*IEEE802.3cg TF*

*Comments on draft*

*May 18<sup>th</sup> 2018*

Figure 147-6—PCS Receive state diagram (1 of 2)

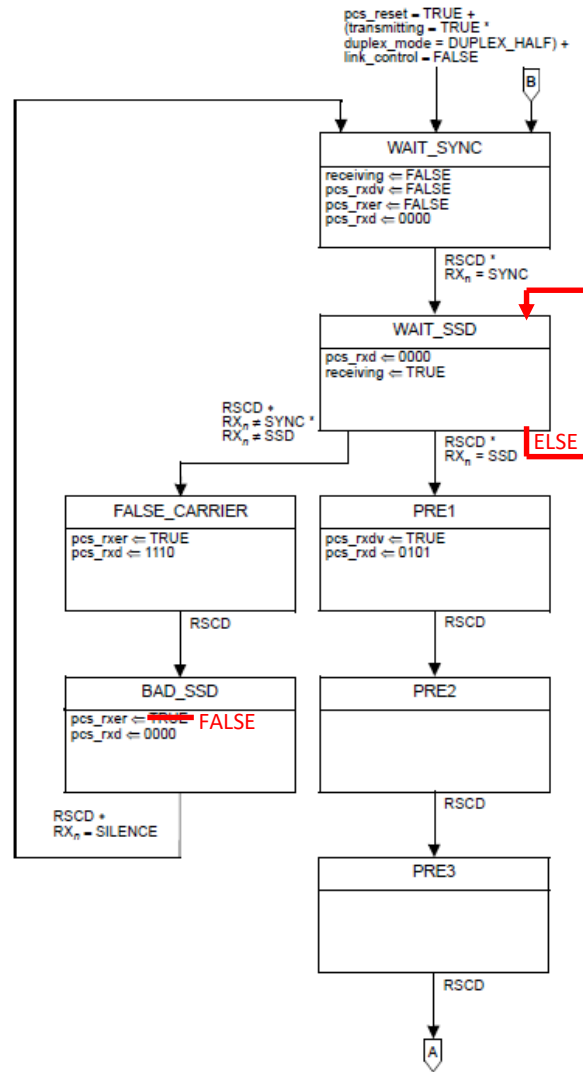
Error occurred when porting the picture to Frame from draft 1.0

Figure TBD#1

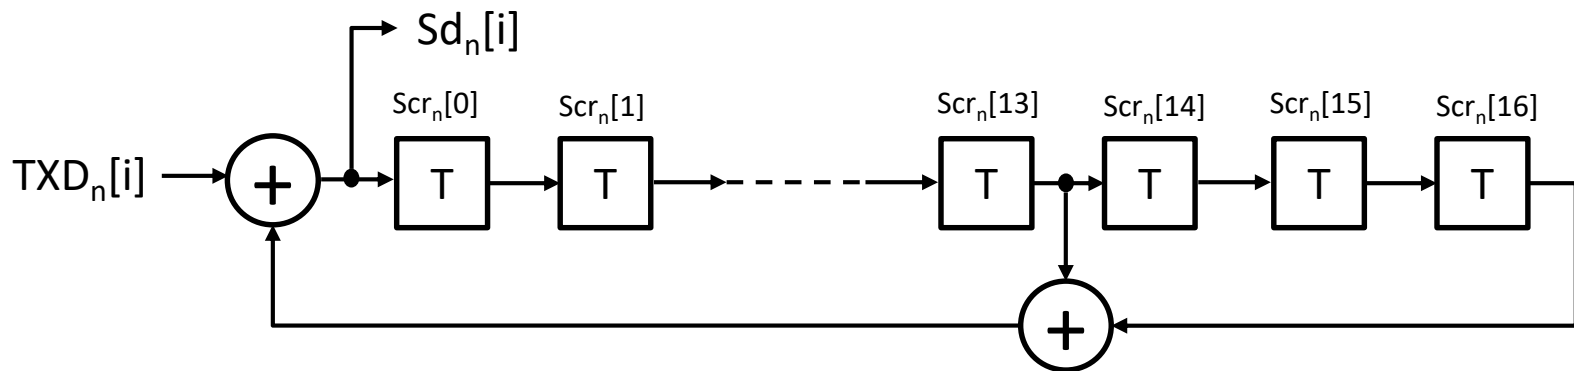
# #320 → Scrambler - Proposed text changes

The PCS Transmit function shall implement multiplicative scrambling using the following generator polynomial:

$$g(x) = 1 + x^{14} + x^{17}$$

An implementation of self-synchronizing scrambler by linear-feedback shift register is shown in figure TBD#1. The bits stored in the shift register delay line at time  $n$  are denoted by  $Scr_n[16:0]$ . At every MII clock cycle, for each bit of  $TXD[3:0]$  the scrambler is advanced by one bit, and the output bit  $Sd_n[i]$  represented by the exclusive OR of  $Scr_n[13]$ ,  $Scr_n[16]$  and  $TXD[i]$  is shifted in as new  $Scr_n[0]$ , with  $i$  ranging from 0 to 3 (i.e. LSB first). The scrambler is reset upon execution of the PCS Reset function. If PCS Reset is executed, all bits of the 17-bit vector representing the self-synchronizing scrambler state are arbitrarily set. The initialization of the scrambler state is left to the implementer. In no case shall the scrambler state be initialized to all zeros.

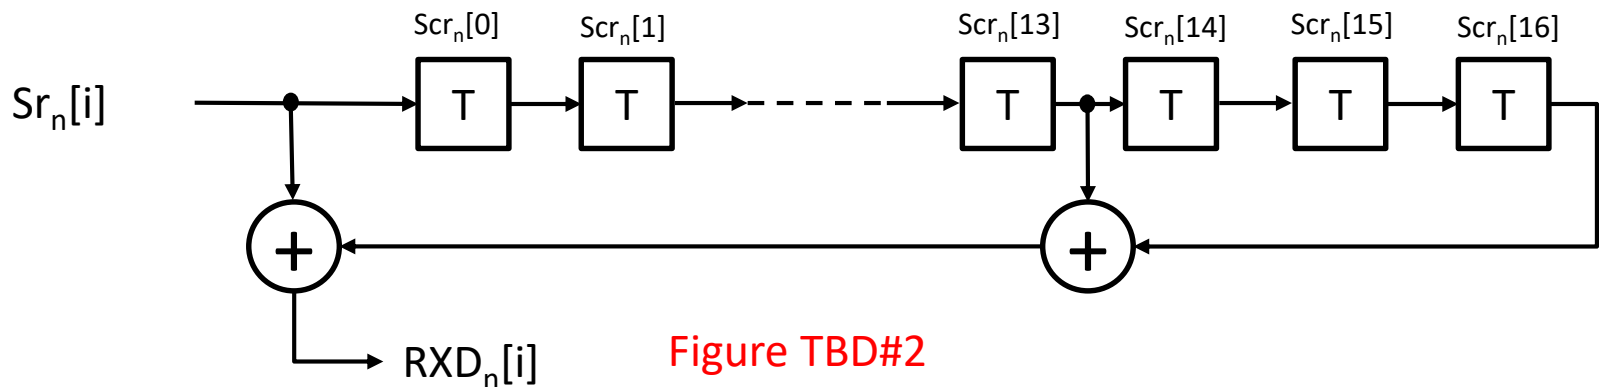
# #322 → Scrambler - Proposed text changes

**precnt**                      **counter for preamble regeneration**

Figure 147-6—PCS Receive state diagram (1 of 2)

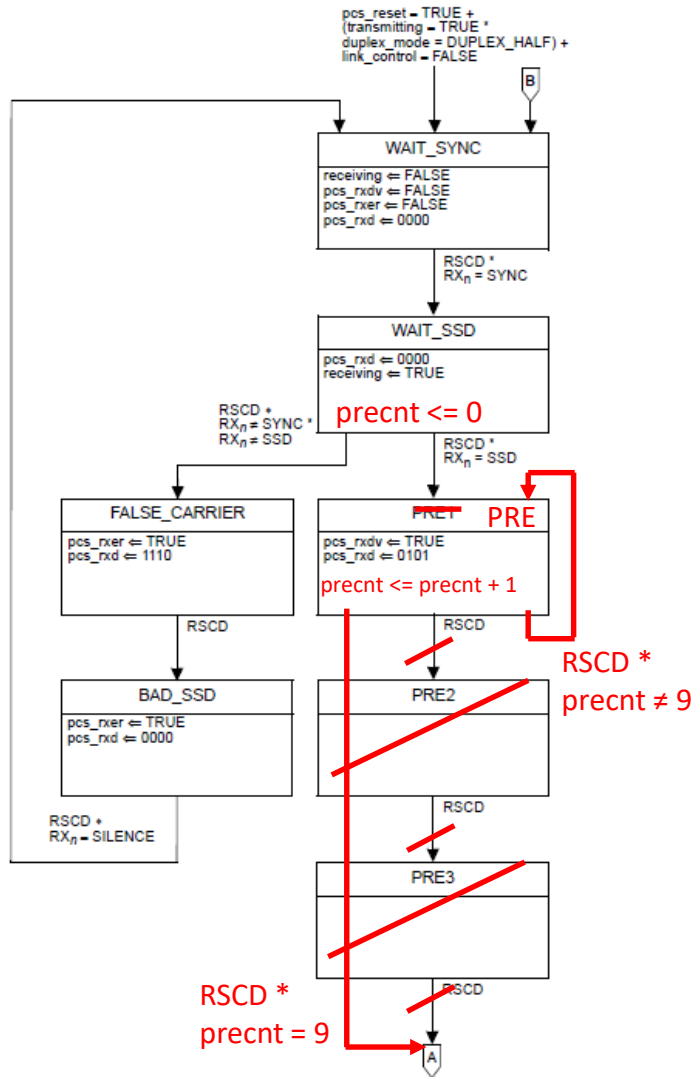
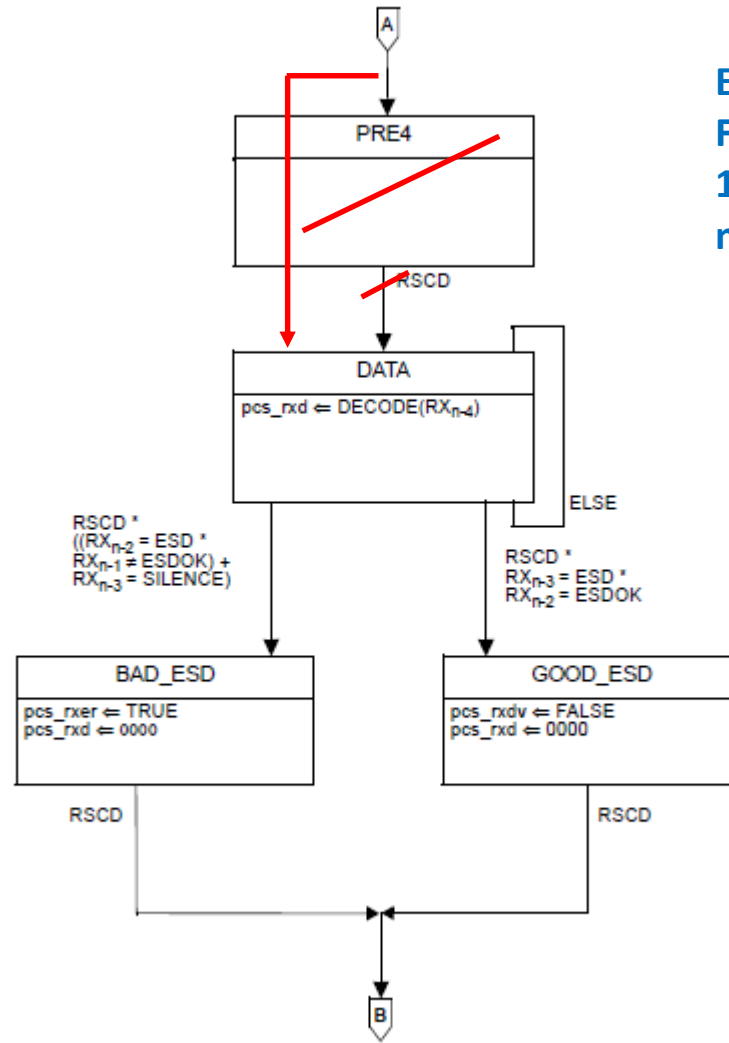
# #324 → Scrambler - Proposed text changes

EDIT. NOTE:  
Fig 147-6 and  
147-7 could be  
merged

Figure 148-6—PLCA DATA state diagram (2 of 2)

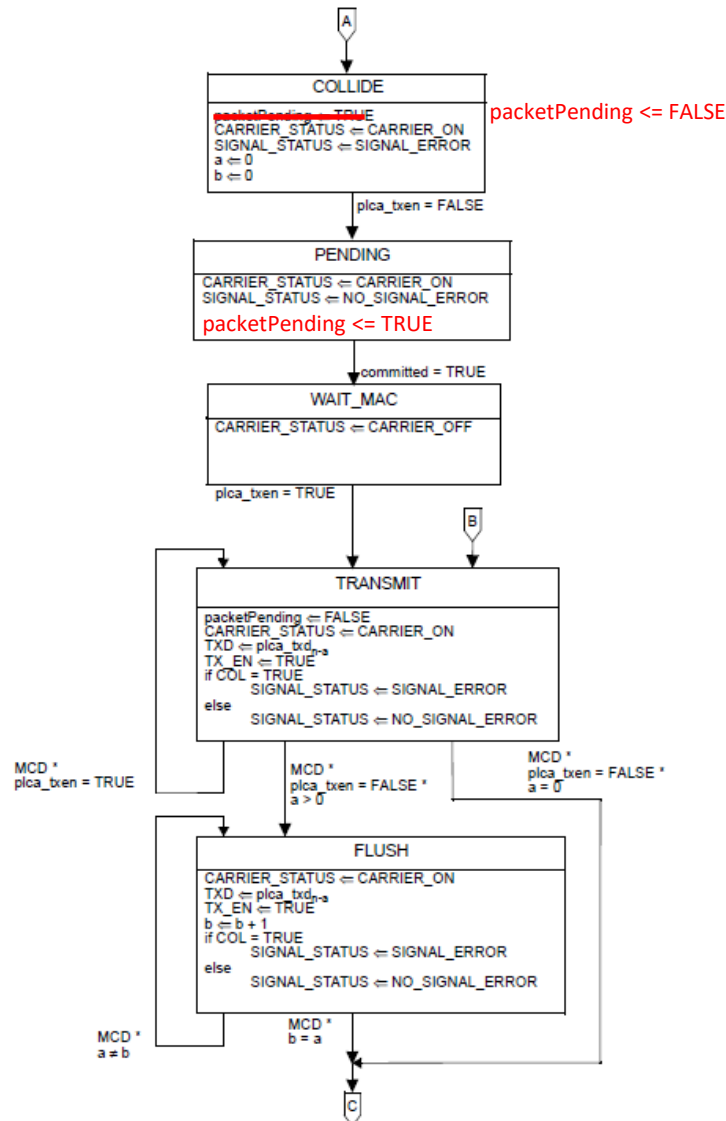
# #326 → Figure 148-6

**Rationale:** In mis-configured networks physical collisions might happen. In such case setting packetPending flag in PLCA Data state machine in COLLIDE state may cause trouble (e.g. COMMITTING while JAMMING).

Figure 148-3—PLCA Control state diagram (1 of 2)

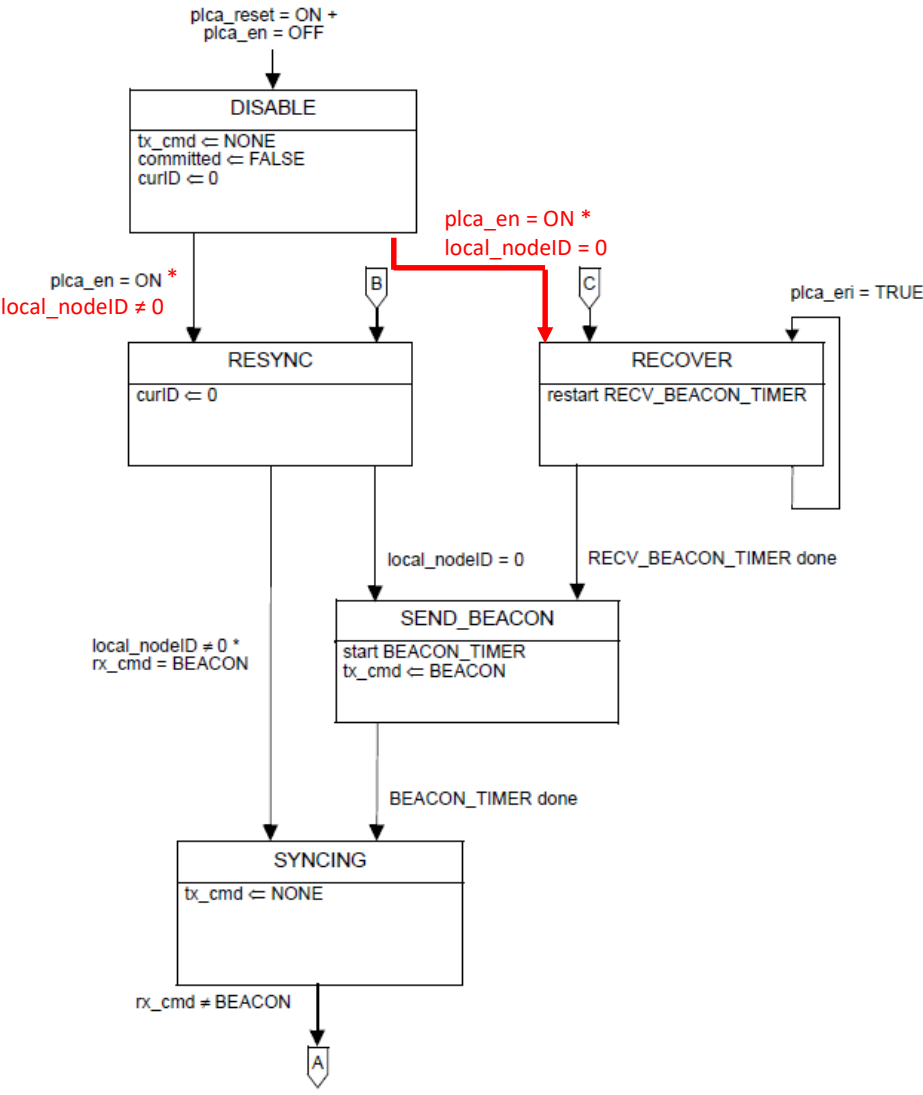
# #328 → Figure 148-3

**Rationale:** The node with ID = 0 could be reset in the middle of a BEACON cycle and start over sending a new BEACON while other PHYs are still in the process of transmitting / waiting their TO. To avoid this the node with ID = 0 could start in recovery mode and wait for the media to be silent before sending the BEACON

Figure 148-5—PLCA DATA state diagram (1 of 2)

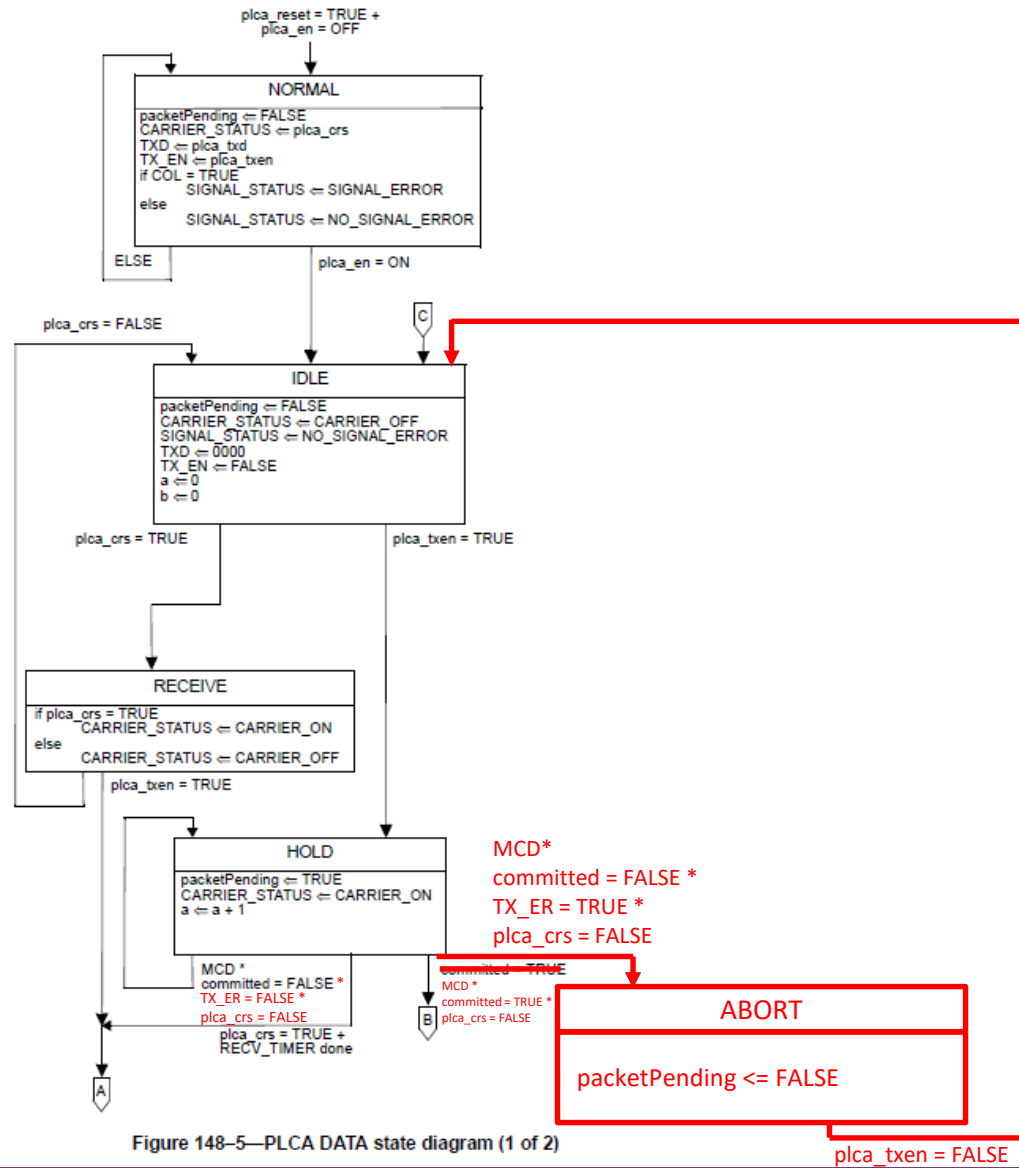
# #331 (TX\_ER) → Figure 148-5
